**Attachment 1
NRC3-12-0003**

**Table of RAI Response Dates
(5 pages)**

Response to RAI Letter No. 70
(eRAI Tracking No. 6217)

Figure 1: Comparison of mean of response spectra (5 percent damping) for weakly matched time histories to the target DE spectra for the 10^{-3} high frequency (HF) motions

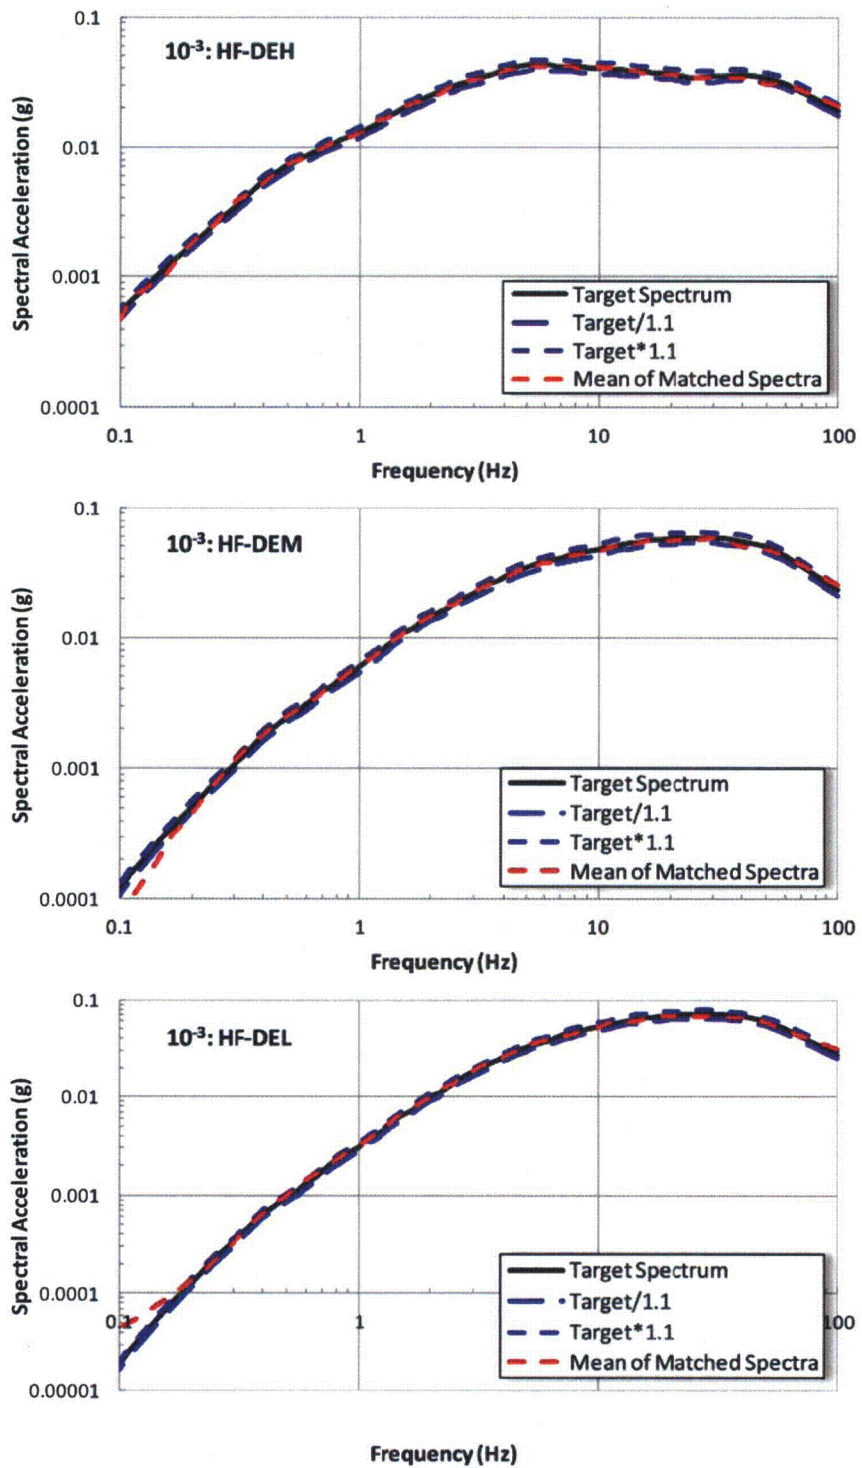
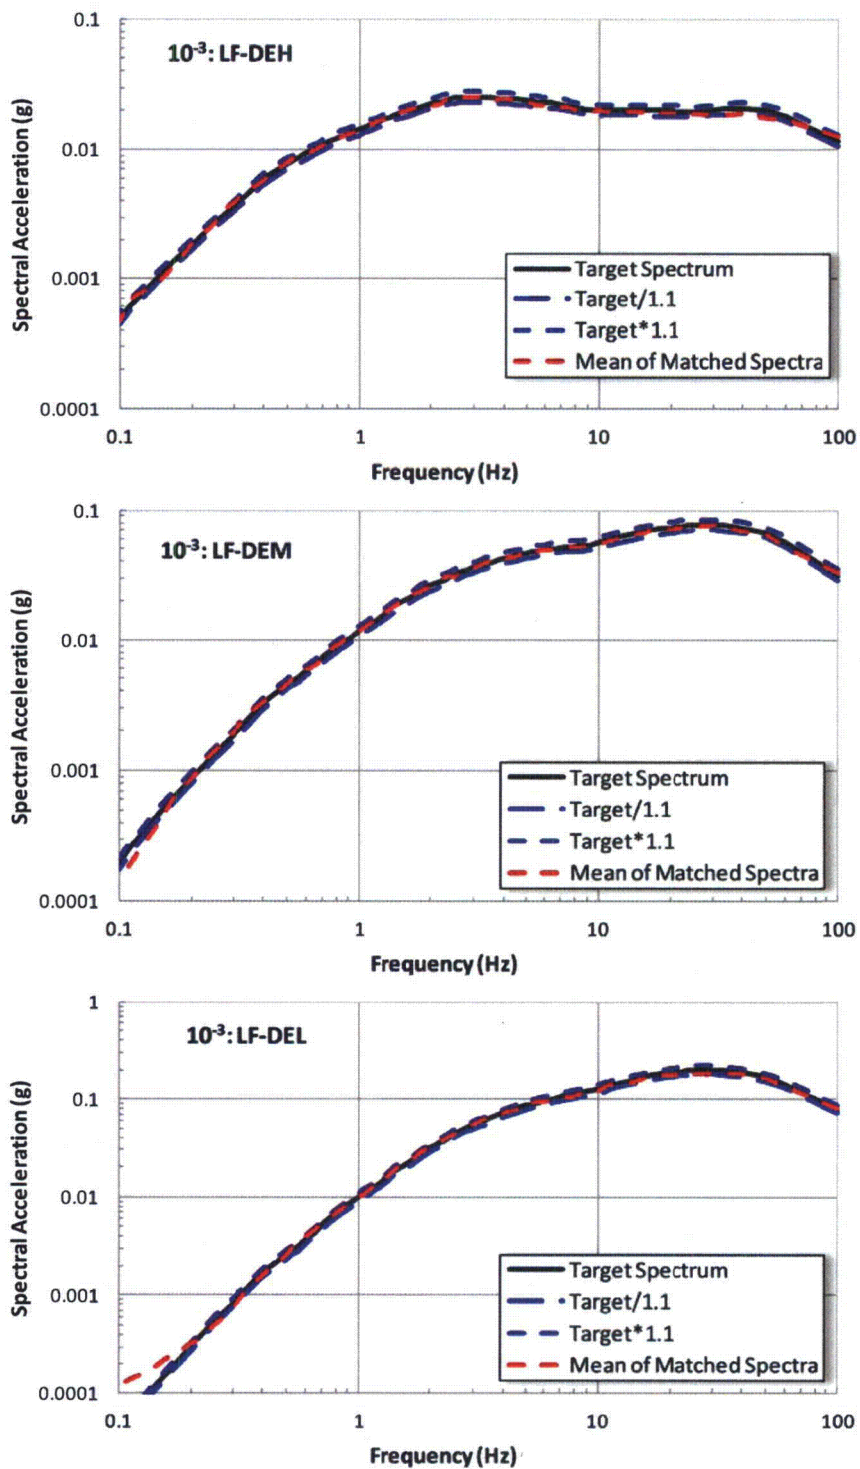
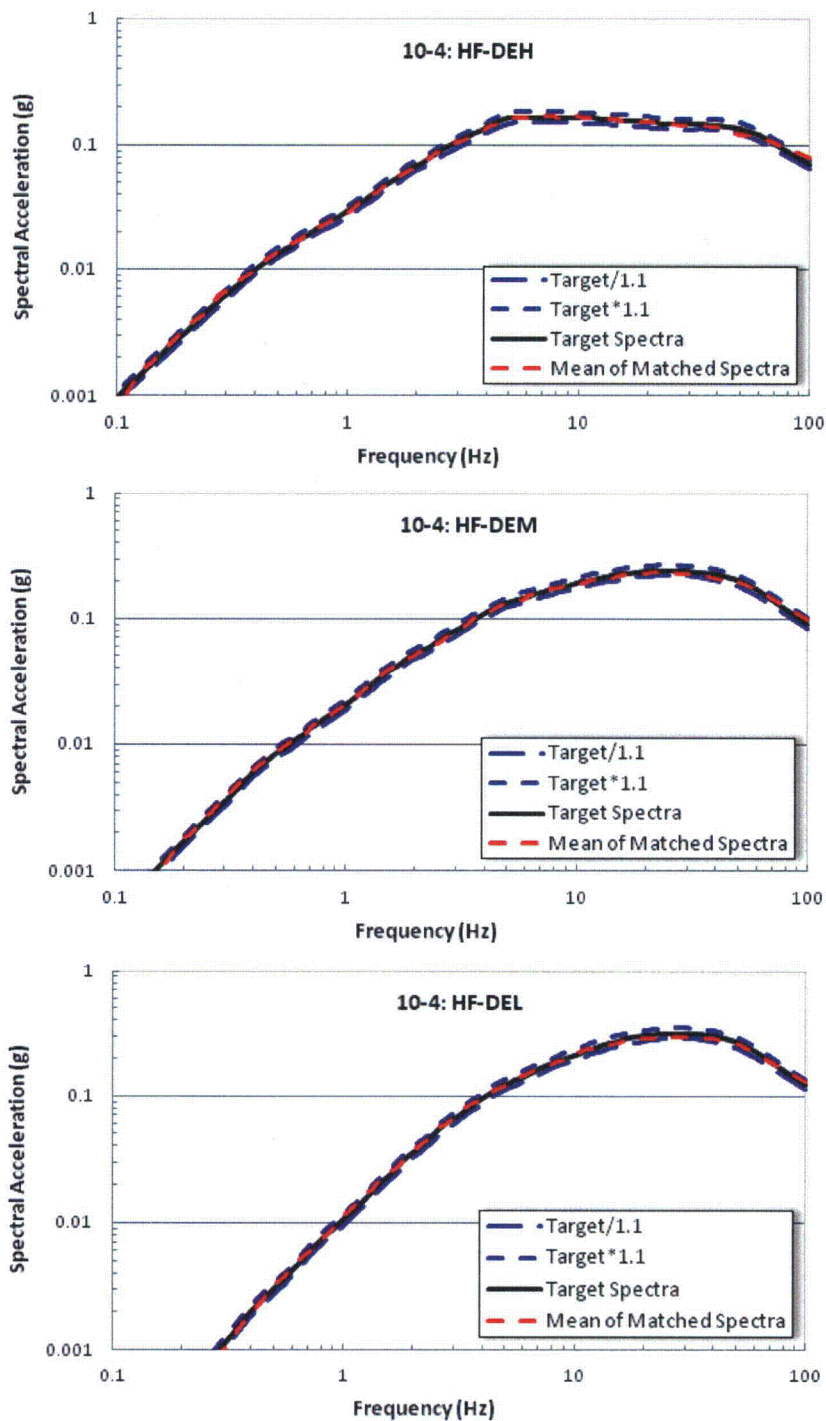
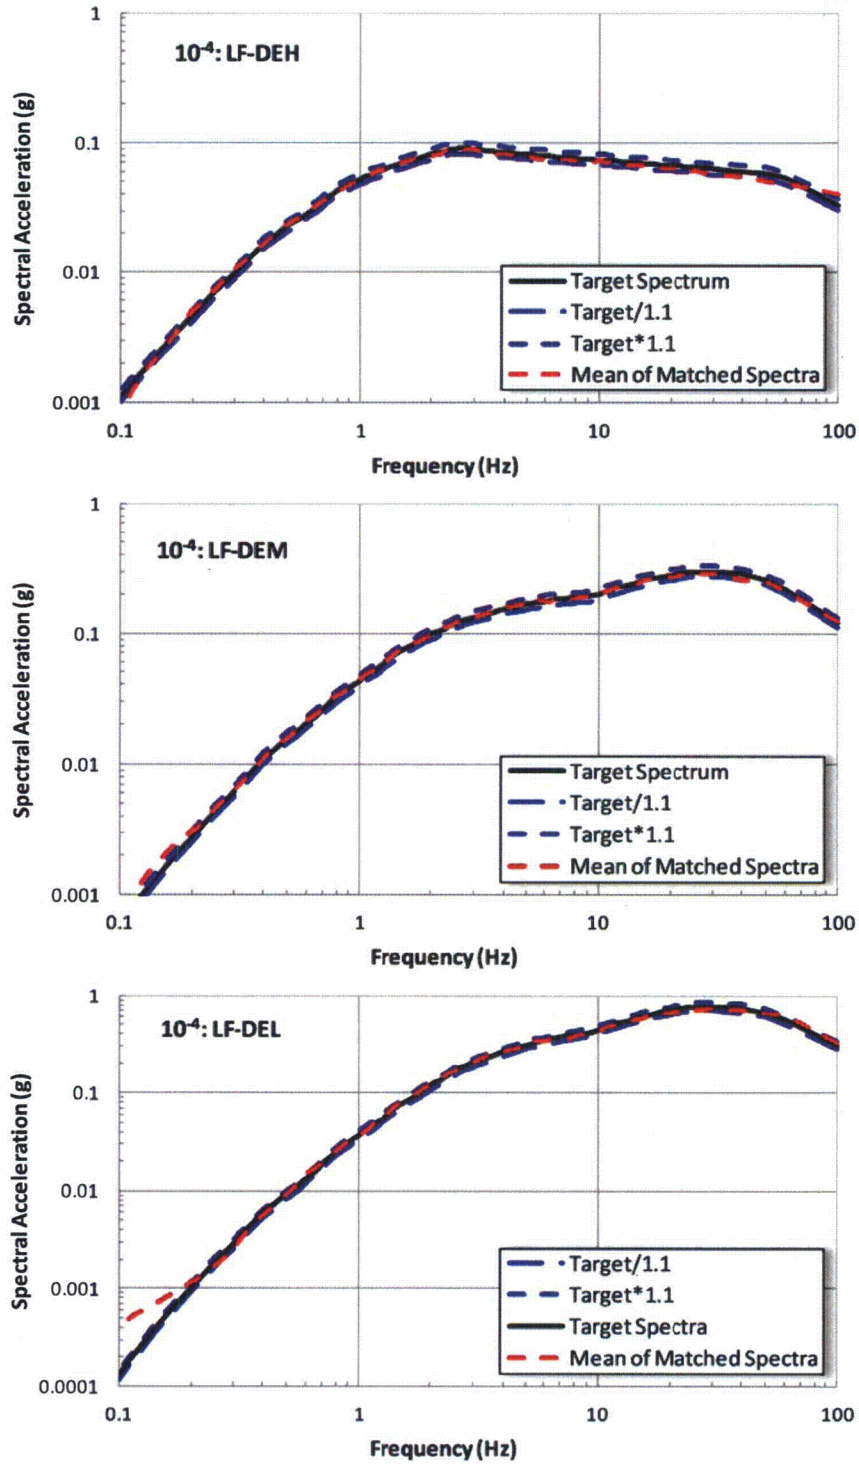
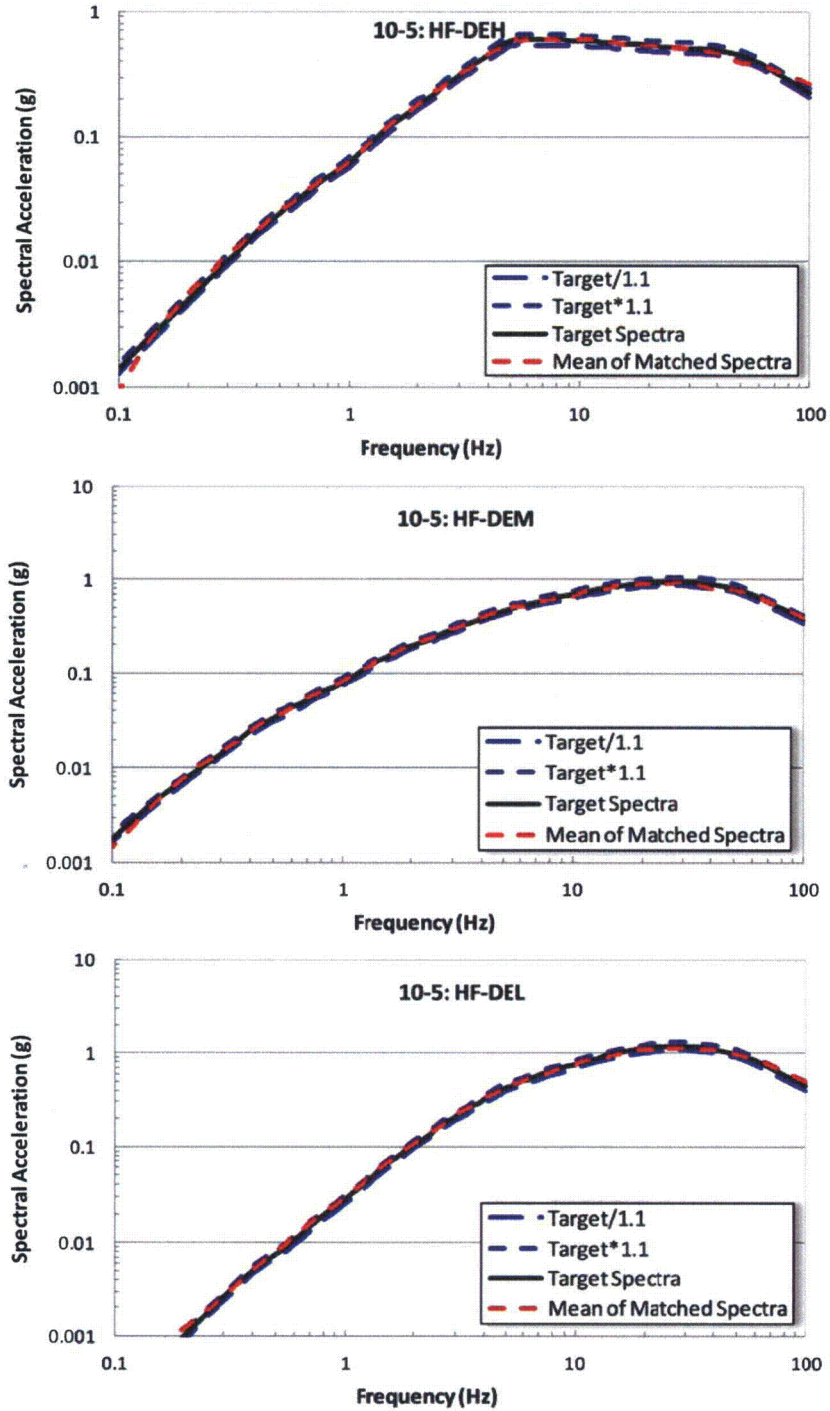
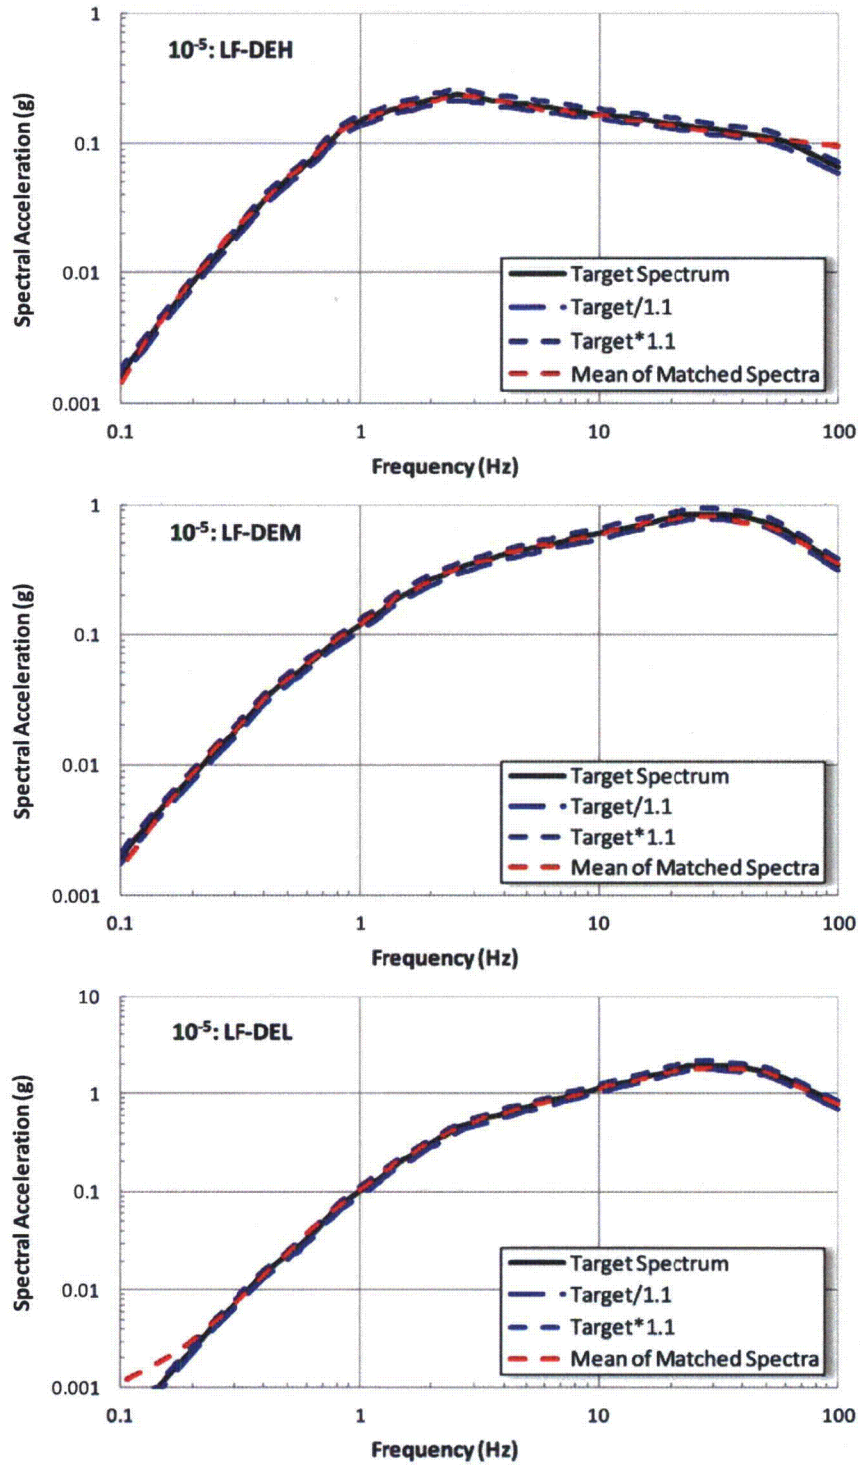
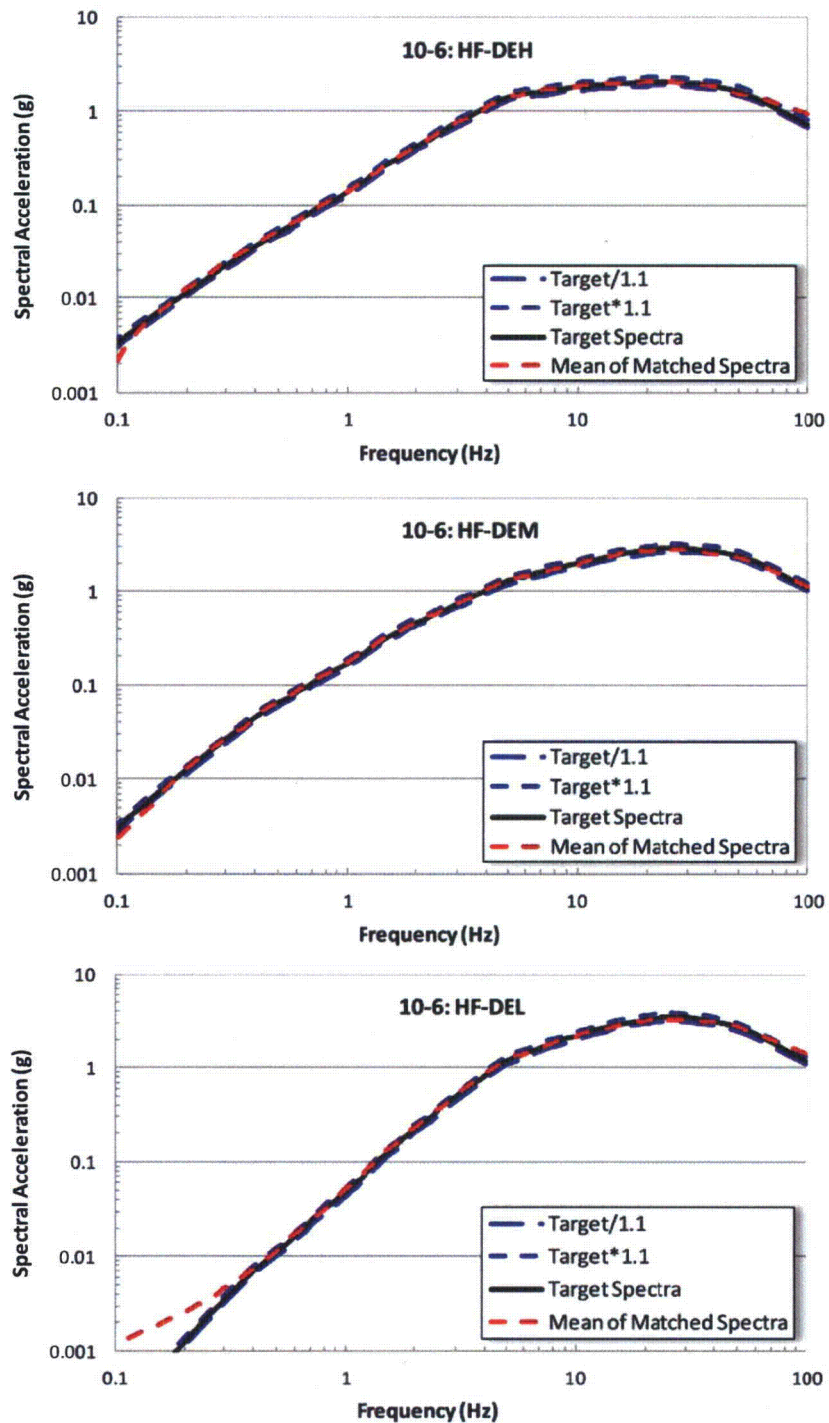
FSAR Section 2.5.2.5.2 indicates that the selected time histories were scaled to approximately match the target DE spectrum using a limited number of iterations of the program RASCALS. Please provide more detail regarding the scaling process. In addition, please quantitatively compare the mean response spectrum of each suite of scaled time histories to the respective target spectrum.

DE target response spectra were developed to represent the contributions to the Fermi 3 site hazard for high frequency (HF) and low frequency (LF) ground motions. DE spectra were developed for hazard levels corresponding to 10^{-3} , 10^{-4} , 10^{-5} , and 10^{-6} mean annual frequencies of exceedance. The target magnitudes and distances for each DE are listed in FSAR Table 2.5.2-219. For each case, three DE spectra are defined: a high magnitude target, DEH; an intermediate magnitude target, DEM; and a low magnitude target, DEL. As described in FSAR Subsection 2.5.2.5.2, the 30 time histories in the appropriate magnitude and distance bin of the central and eastern United States (CEUS) time history database in NUREG/CR-6728 (McGuire et al., 2001) were weakly matched to each DE spectrum. Figures 1 through 8 compare the target DE spectra to the mean response spectra for the 30 scaled time histories for HF and LF motions at the four hazard levels. Each plot also shows the target DE spectrum multiplied by 1.1 and divided by 1.1 to provide a sense of the accuracy of the average fit.

The comparisons shown on Figures 1 through 8 show that the means of the response spectral ordinates for the scaled time histories are generally within a factor of 1.1 of the target DE response spectrum. All spectra shown on the figures are for 5 percent damping. In some cases, large deviations from the target spectrum occur at frequencies below about 0.2 Hz. Because the fundamental frequencies of the site profiles are approximately 3 Hz, the deviations at very low frequencies have little impact, as indicated by the amplification factors near unity for frequencies less than 1 Hz (e.g., FSAR Figure 2.5.2-270). In a few cases for the LF DE spectra (LF DEH for 10^{-5} and 10^{-6}), large deviations from the target spectrum occur at frequencies above 50 Hz. These deviations are not significant because the motions in this frequency range are not used to define the LF site amplification factors.

The results shown on Figures 1 through 8 indicate that the mean of the response spectra for the weakly scaled time histories provide a good representation of the DE target response spectra.
